**Protea Village Basic Assessment: Issues Trail- October 2020**

Figure 1 Pathways suggested by I&AP

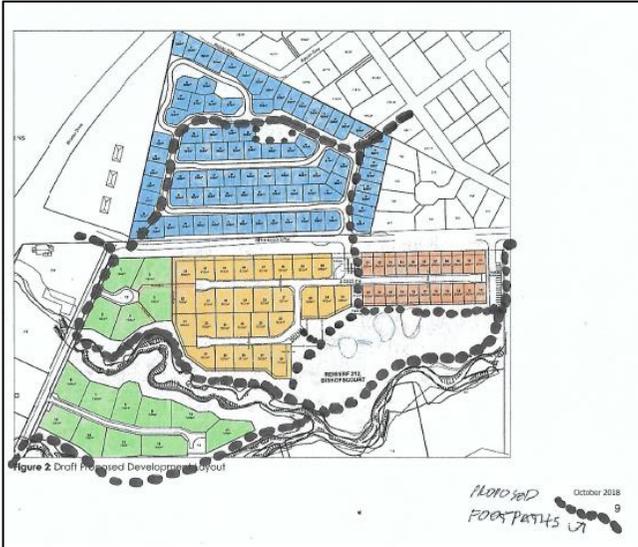
**187. It has been suggested that an integrated pathway system be provided which reflects current desire lines. Please clarify the rationale for locating the proposed lines as they are and also comment on why the proposal in Figure 1 can only be fulfilled in part.**  
Most of the current desire lines are along the streams and these

would be retained in the same general location. Existing paths that cross the site and hinder a sensible and cost-effective layout would not be retained, but alternative routes are generally available.

The roads on Erf 242 would be zoned Public Road and could thus be used by pedestrians as walk paths, bearing in mind that a singular access point to Erf 242 would be provided on Kirstenbosch Drive.
